GUIDANCE FOR THE READER

SD-BWI-CR-018, "Draft Waste Acceptance Requirements for the BWIP,"
June 1983.

The BWIP Reply Proposed Dispositions to the DOE-RL Review Comments
 DOE COMMENTS ON SD-BWI-CR-018
 DRAFT WASTE ACCEPTANCE REQUIREMENTS
 FOR THE BASALT WASTE ISOLATION PROJECT

The Revised (March 1984) Terminology for components
of the BWIP Waste Package

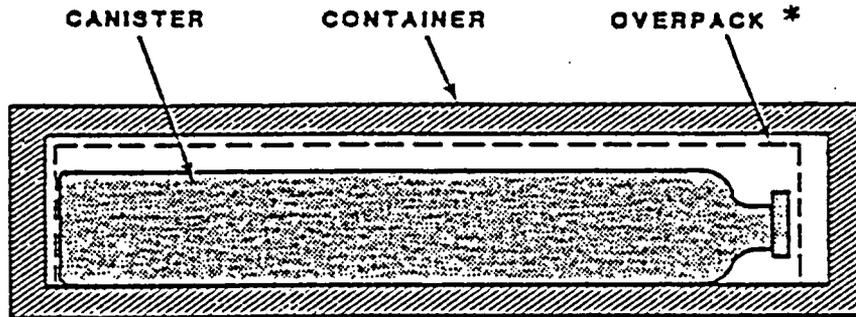
Note: The BWIP has recently revised the naming applied to waste package components in an effort to achieve a more logical terminology system and also more commonality with component nomenclature used by other NWTs programs, DOE, NRC and others. A copy of the new terminology for components in the BWIP waste package design is attached.

BWIP_ACTION: Will add the term "canister" to document glossary, and revise the waste package component definitions and usages in the document according to the recent BWIP changes.
